TOWN OF BEAUFORT
FIRE STATION #2 ADDITION
BEAUFORT, NORTH CAROLINA

ADDENDUM 2

September 4, 2026

Retractable Cord Reel - Heavy Duty, 65'

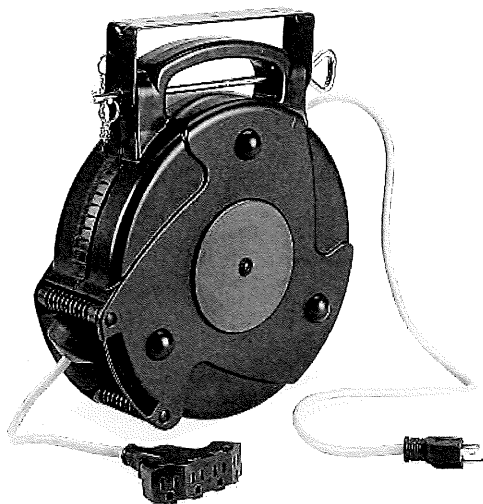
4. The door handle into the decontamination room does not need to lock.
5. The specification for the retractable cord reel to be provided and installed by the contractor is included with this addendum.

8' Ceiling fan

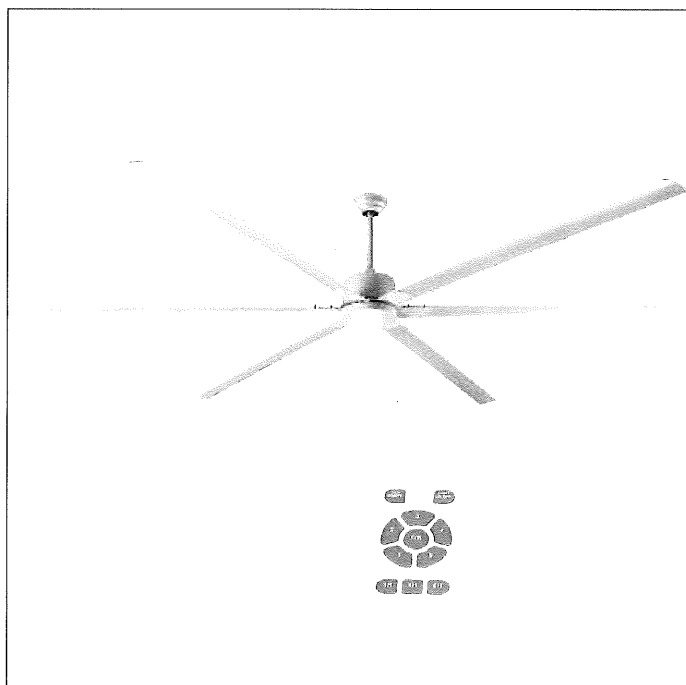
7. The specification for the ceiling fan to be provided by the Town and installed by the contractor is provided with this addendum.
8. The requirement for bid, performance, and payment bonds will be decided by the Town of Beaufort no later than Tuesday.
